**CITY OF ISANTI
PLANNING COMMISSION MEETING
TUESDAY, July 19, 2022
Immediately following 7:30pm Budget Work Session
CITY HALL**

SUBJECT: Site Plan Review and CUP Approval for a Dairy Queen building with a drive-thru and outdoor patio area located at 280 5th Ave NE

Date: July 7, 2022
To: Stephanie Hillesheim, Community Development Director
From: Jason W Cook, P.E.
City Engineer
Subject: Dairy Queen – Site Plan Review
City of Isanti, MN
Project No.: 0R1.126218

C401

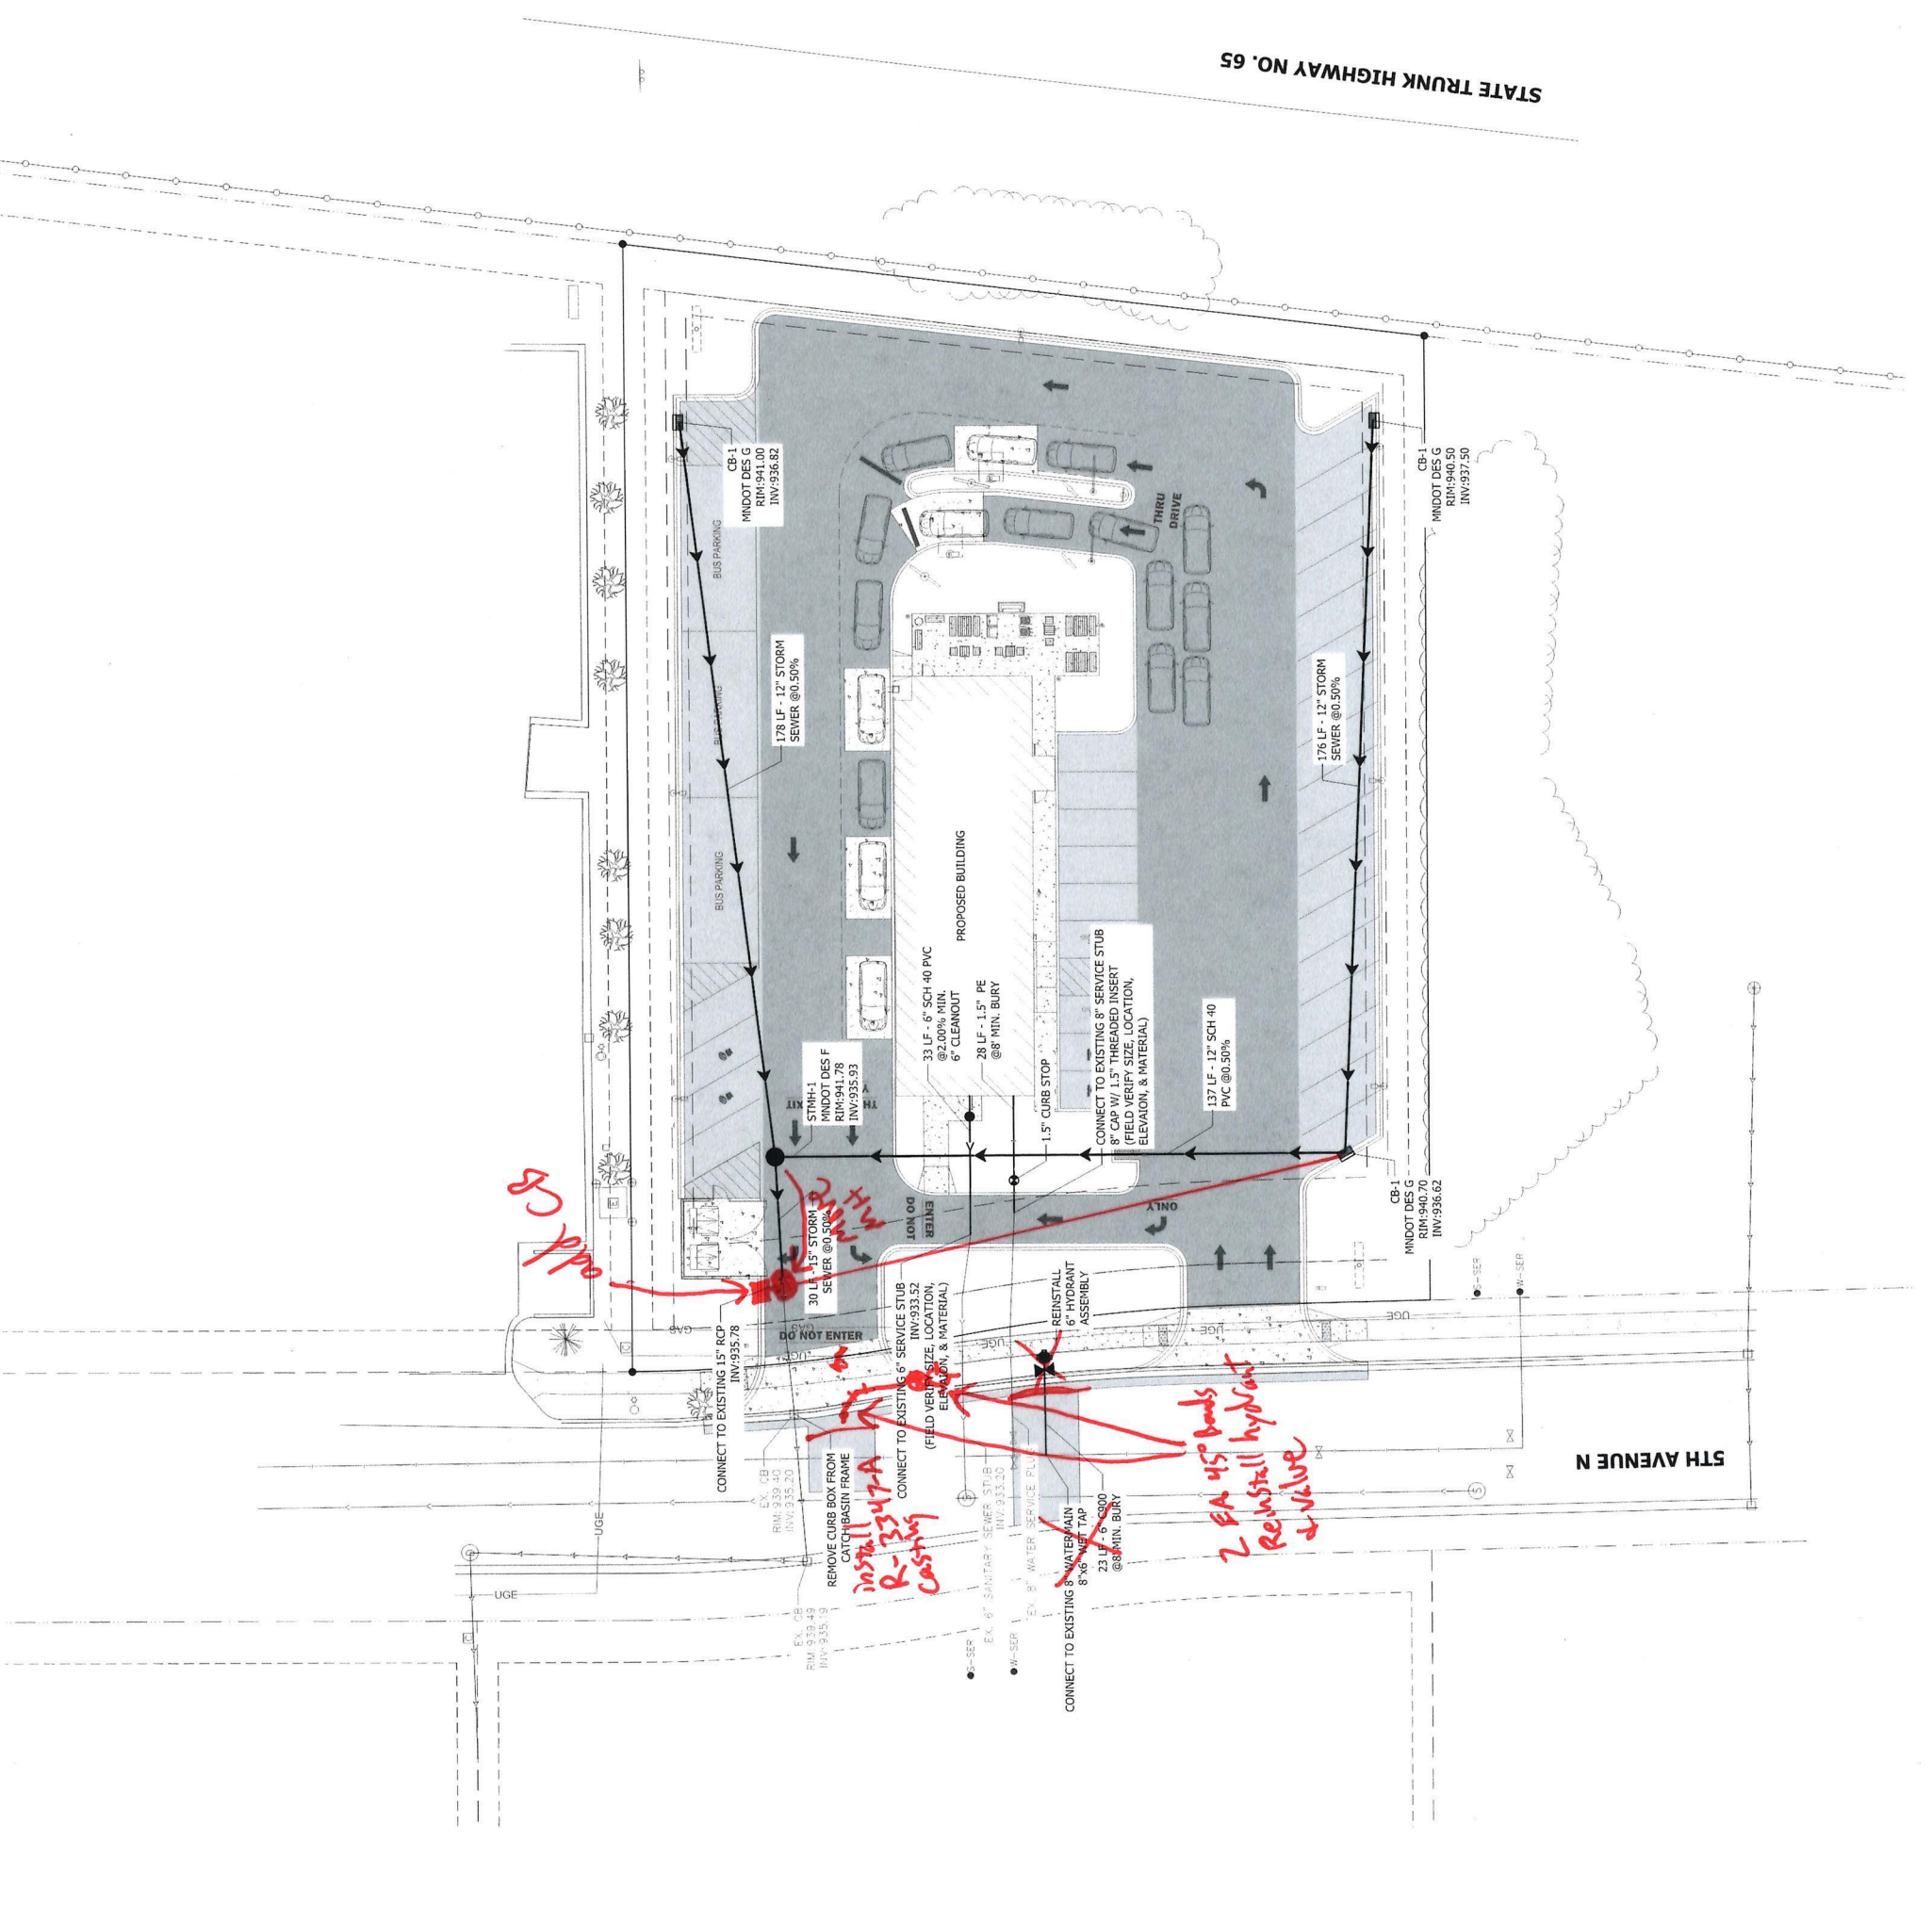
3. Sheet C401 – Utility Plan:
 - a. Call out a Neenah R-3347-A casting to replace the existing casting on the existing catch basin that will now fall in the driveway. Revise on C602 table as well.

- b. We do not want additional taps made onto the waterline, nor the full street being cut into and closed, therefor, show removing the existing hydrant and valve, adding 2 45-degree bends and reinstalling the hydrant and valve on the south side of the new exit, centered in the boulevard.

- c. A large portion of the site in the NW area drains to the street, this needs to be collected on site. Move STMH-1 to the connection point of the existing storm stub and add a new Catch basin next to the trash enclosure.
4. Sheet 501 – Erosion Control Plan:
 - a. All turf establishment shall be sod, not seed, per City standard.
5. Sheet C6.02 – SWPPP Narrative:
 - a. Submit NPDES Permit to City prior to beginning work.
 - b. Submit City SWPPP checklist (attached)

CONCRETE VALLEY GUTTER
NOT TO SCALE

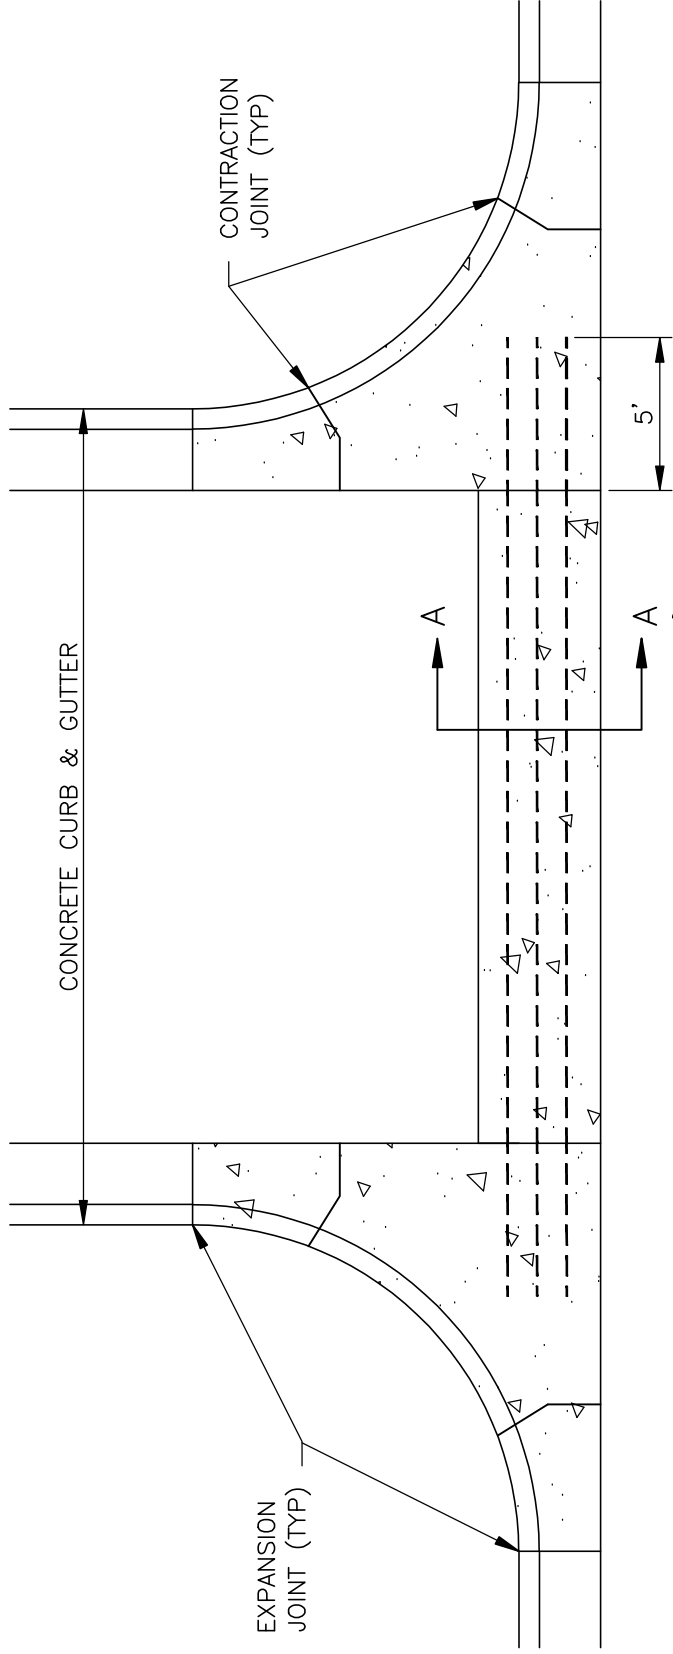
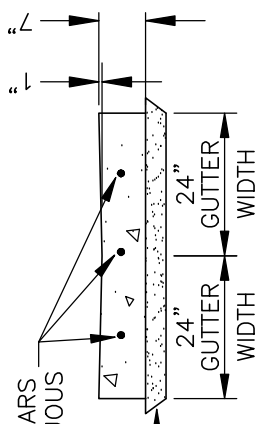
- c. Cut a minimum 2-foot bit patch width along the curb.
2. Sheet C201 Civil Site Plan:
 - a. Use the heavy duty pavement section on 5th Avenue.
 - b. Clarify which “directional sign” will be used at the entrance and exit.
